Permit Application Review

Permit No. 2019-71
Received complete: August 16, 2019

Applicant: Luigi Bernardi; Arcadia on France, LLC.
Consultant: Zachary Webber; Loucks
Project: The Shoppes at Estelle
Location: 6950 France Avenue: Edina
Rule(s): 4,5,10,11 and 12
Reviewer: BCO

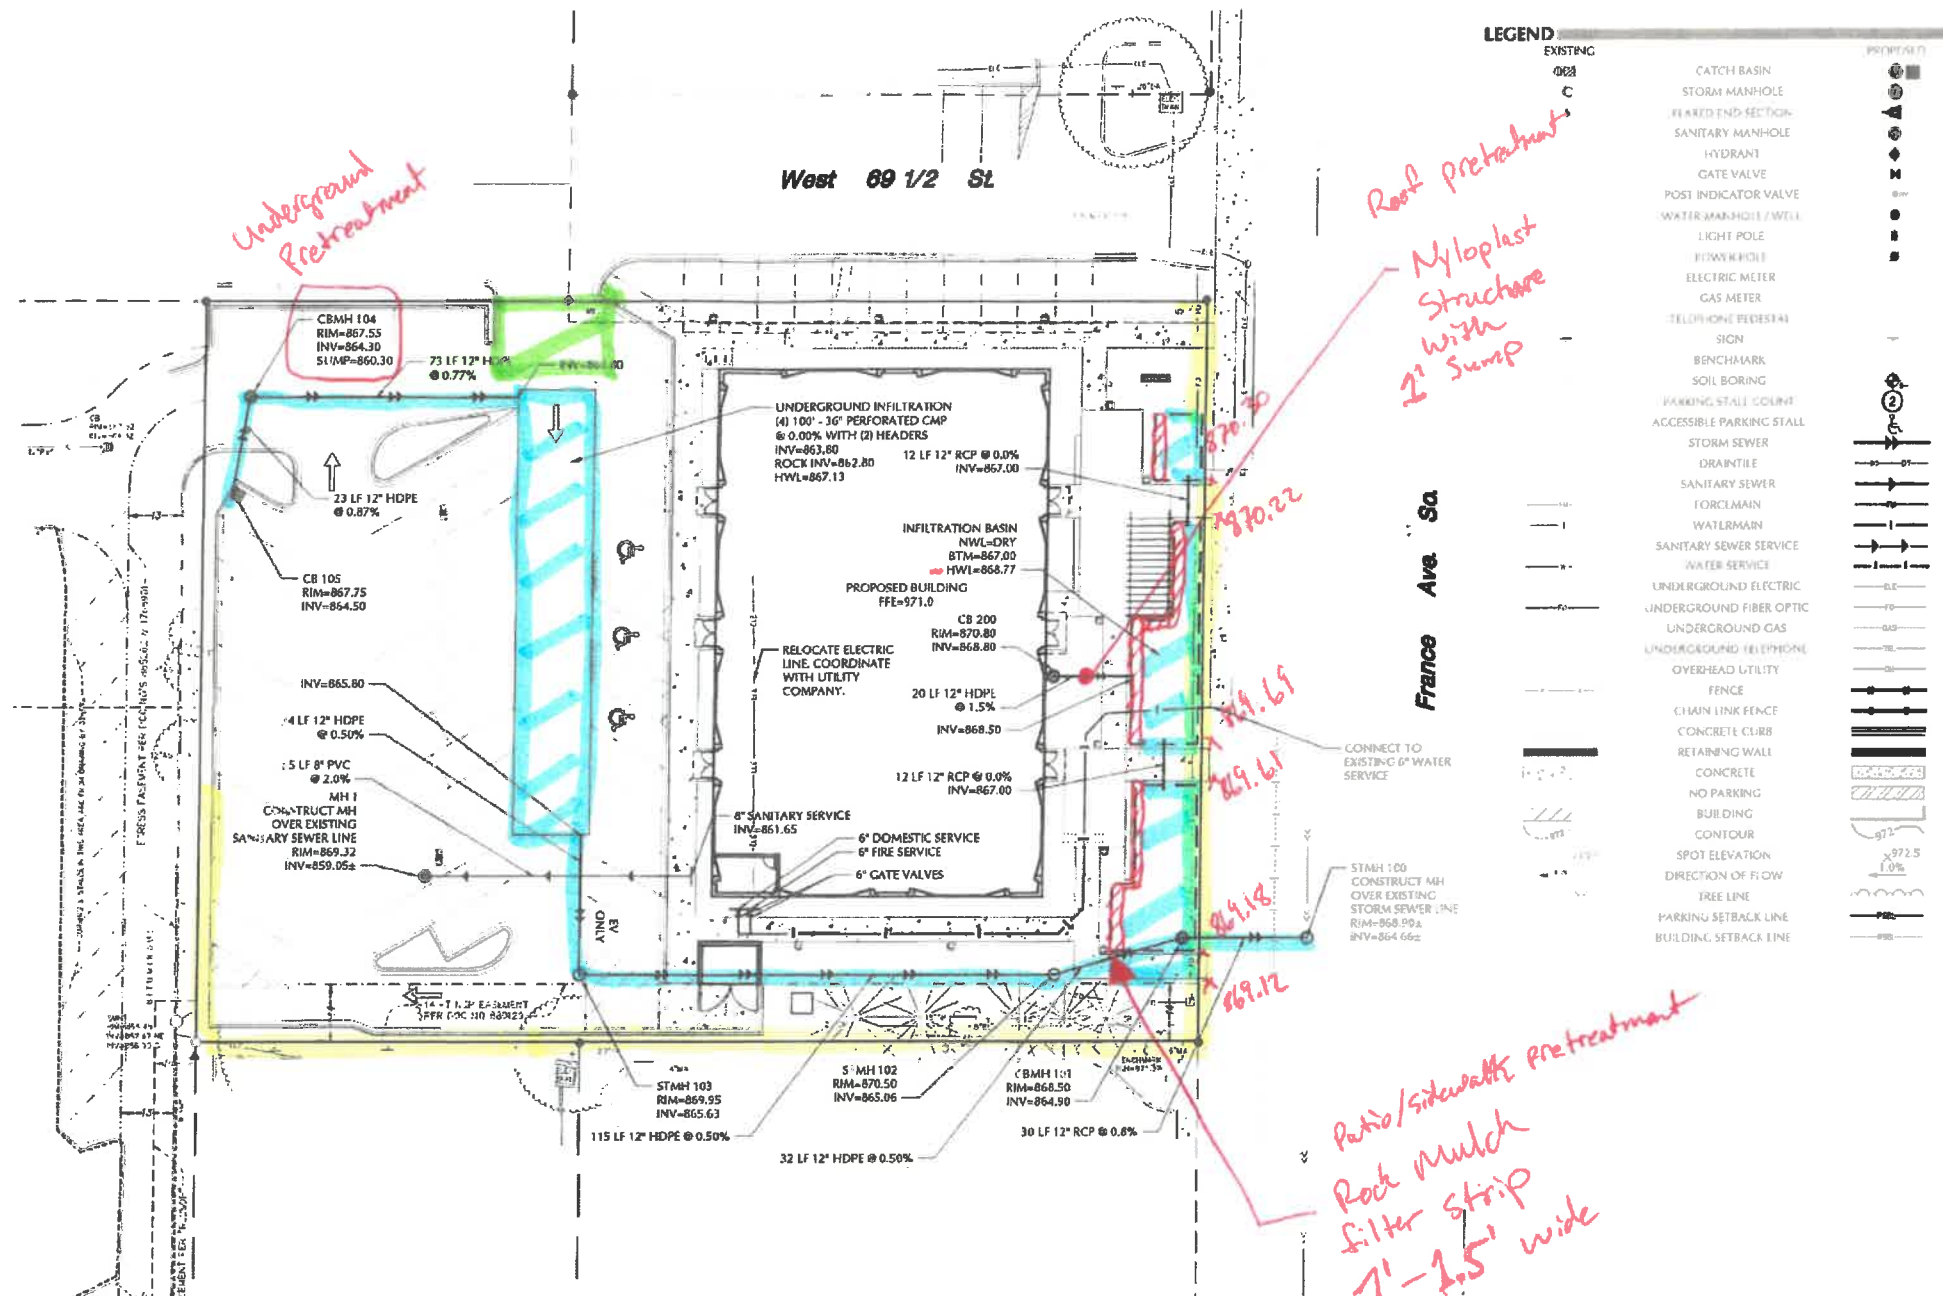
Currently storm water drainage goes west to a neighborhood that is severely challenged in regards to storm water drainage service and flood protection. A screen shot of the 1% annual flood shape is provided.

In the interest of incrementally improving this condition, staff has asked the applicant to try to discharge some of the storm water east to the France Avenue storm sewer system. They intend to still control rate and volume with the use of underground tanks and raingardens.
